Roz Barr Architects

Proposed Roof Terrace- Further Information

Updated drawings with the revised design and further information for the planning application relating to:

41b England's Lane, London, NW3 4YD

Revised Proposed Rear Elevation
1:100 @ A3

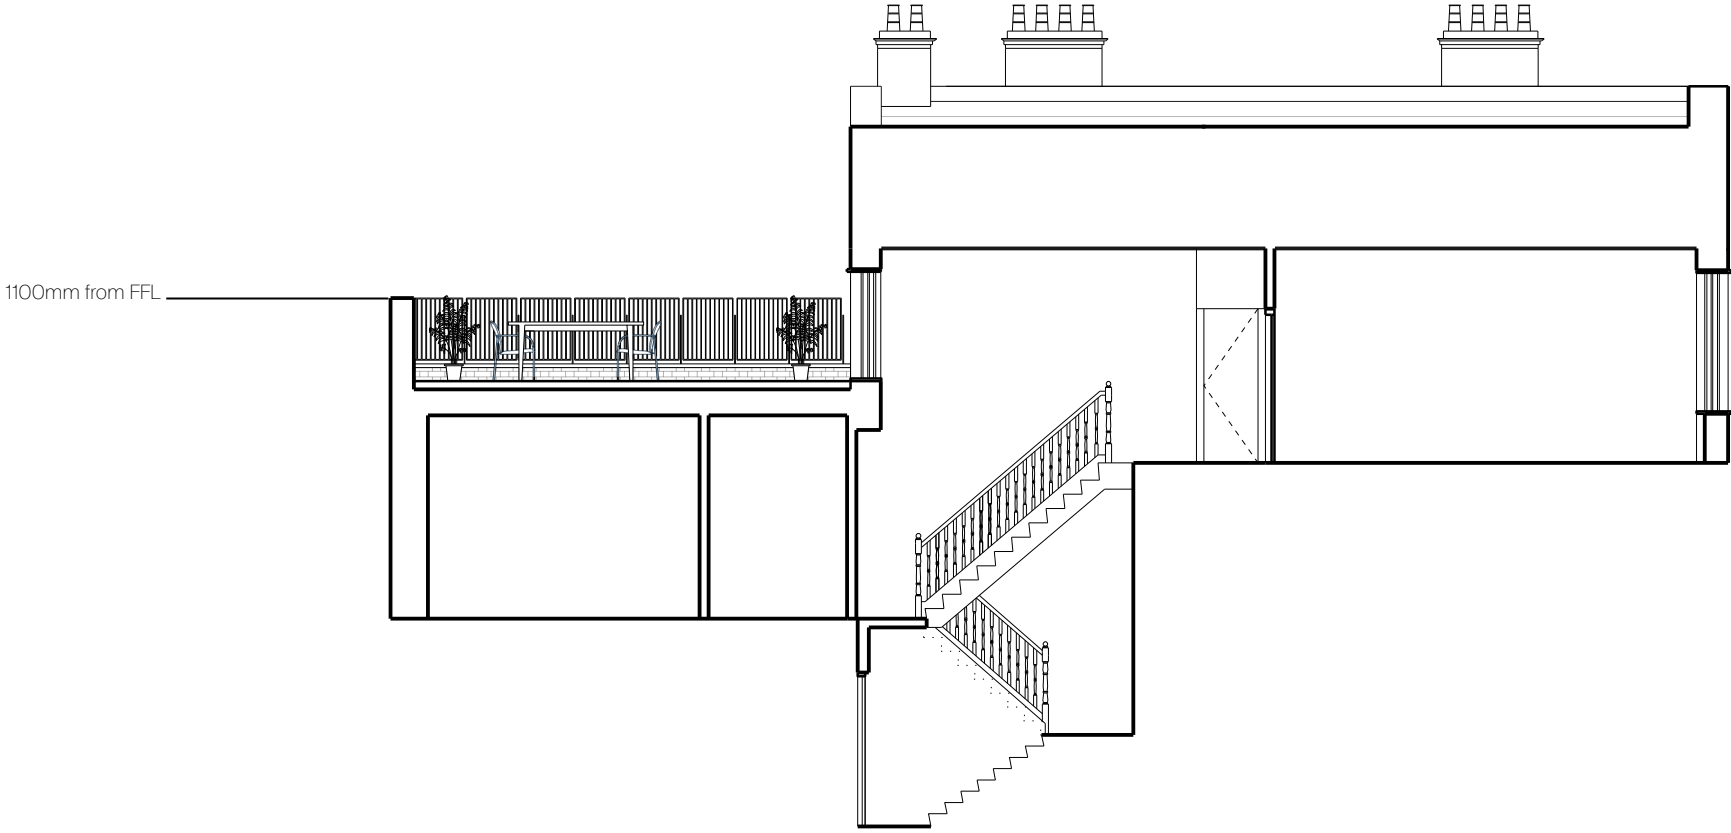
The proposal has been revised in response to the comments regarding the balustrade height and brickwork. The design of the brickwork has been changed to match that of the neighboring properties. Furthermore, the balustrade has been lowered to 875mm, sitting 1100mm from the new FFL of the roof terrace. Due to the height of the existing FFL of the roof- which seems to have previously been rebuilt and raised- the balustrade would be higher than those of the neighboring properties.

Although different in height, the lowered balustrade along with the revised design of the brickwork seeks to better replicate the look of the neighboring roof terraces.
